Model: Bellini-C3 Multi Bypass Tray (ALEUTIAN-B)		Date: 18-Mar-08	No.: MB833001
Modified Article: Cover: Connecting		Prepared by: S. Ishizu	
From: 2nd Tech. Support Sec. Service Support Dept.			
Reason for Modification:	<input type="checkbox"/> Parts catalog correction <input type="checkbox"/> Vendor change <input checked="" type="checkbox"/> Other <input type="checkbox"/> To facilitate assembly <input type="checkbox"/> To improve reliability <input type="checkbox"/> To meet standards <input type="checkbox"/> Part standardization <input type="checkbox"/> Product Safety ()

Model: Bellini-C3 Multi Bypass Tray (ALEUTIAN-B)		Date: 15-May-08	No.: MB833002
Modified Article: Feed Guide Plate		Prepared by: S. Ishizu	
From: 2nd Tech. Support Sec. Service Support Dept.			
Reason for Modification:	<input type="checkbox"/> Parts catalog correction <input type="checkbox"/> Vendor change <input type="checkbox"/> Other <input type="checkbox"/> To facilitate assembly <input checked="" type="checkbox"/> To improve reliability <input type="checkbox"/> To meet standards <input type="checkbox"/> Part standardization <input type="checkbox"/> Product Safety ()

Model: Bellini-C3 Multi Bypass Tray (ALEU

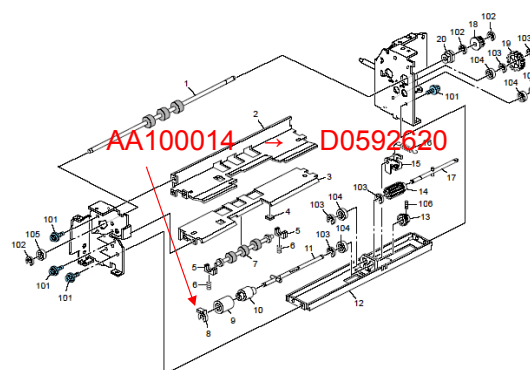
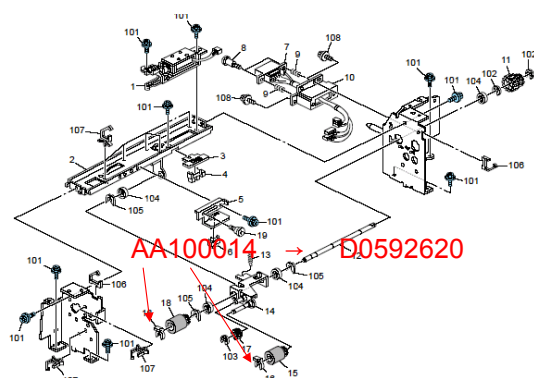
Change/ Reason: Parts standardization with the next model.

2. One 0454006Q will be replaced by B2342390.

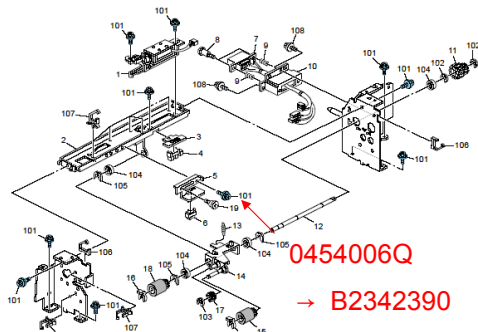
This will be replaced on B8332576 (Paper Feed Sensor Bracket).

Reason: To enable use of TCRU parts

Old part number	New part number	Description	Q'ty	Int	Page	Index	Note
B8332680	B8332780	SIDE FENCE: FRONT: ASS'Y	1	X/O	4	1

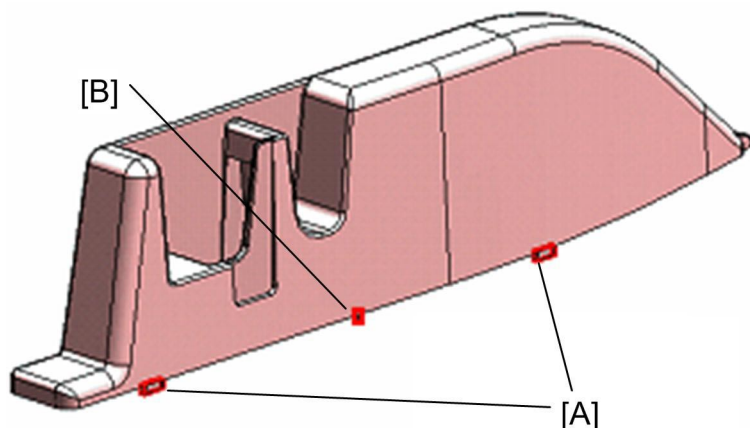
The two projections [A] on the front side fence were deleted and the rib on the front side fence was cut 1 mm.

To improve the movable range of the side fences.
